BOUNTIFUL CITY PLANNING COMMISSION

Planning Commission Staff Report

Item: Variance Request to allow a Retaining Wall over 10' cut/fill Vertically and Encroach on Slopes Thirty Percent (30%) or Greater
Address: 1874 East Ridge Point Drive
Author: Amber Corbridge, Senior Planner
Date: August 1, 2023

PLAN REVIEW
07/12/2023
LLOYD CHENEY
BOUNTIFUL CITY ENGINEER

SITE PLAN			
Scale	Date	Sheet	TS
1"=10'	06/12/2023	SP-1	20-4822

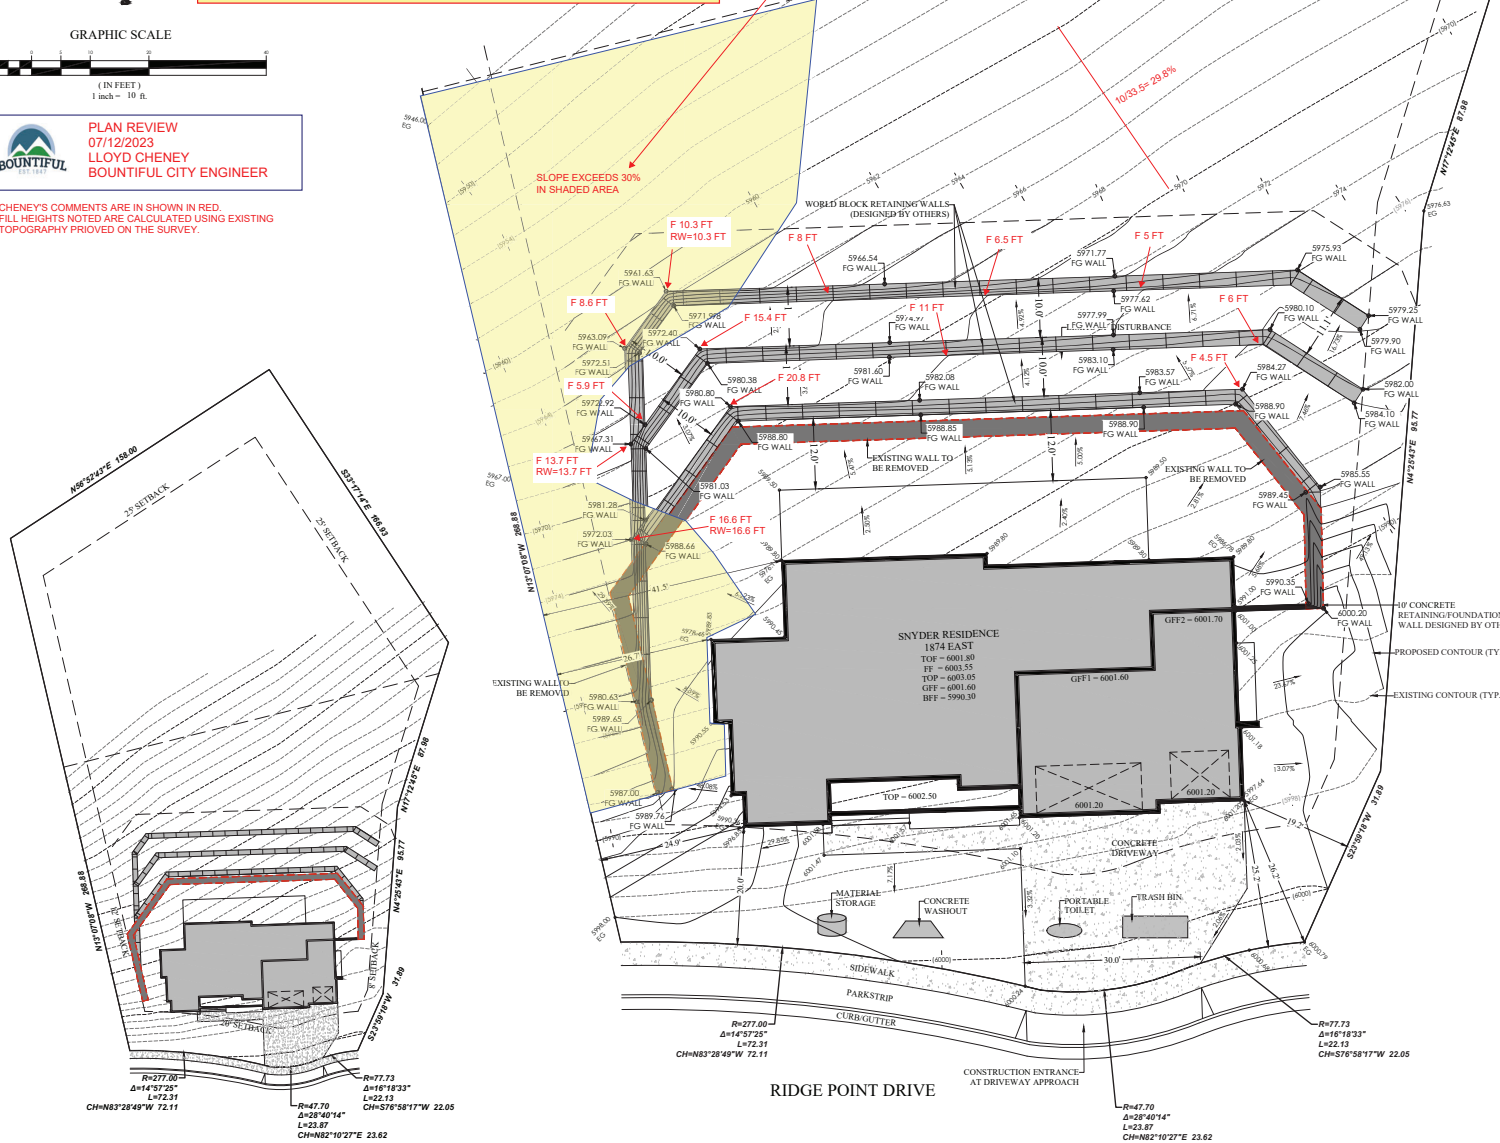
CHENEY'S COMMENTS ARE IN SHOWN IN RED.
FILL HEIGHTS NOTED ARE CALCULATED USING EXISTING TOPOGRAPHY PROVIDED ON THE SURVEY.

Retaining walls, if approved will need to be peer reviewed by Taylor Geotechnical, compaction of all soils behind the walls will also need to be addressed. (These walls, placement & compaction of soils, and helical piers form the support system for the house, the retaining walls are a vital part of the support system.)

Reviewed by 07/11/2023
Building Department
Don Simons, Building Official
COMMENTS: RED BORDER, YELLOW BACKGROUND & BLUE LETTERS
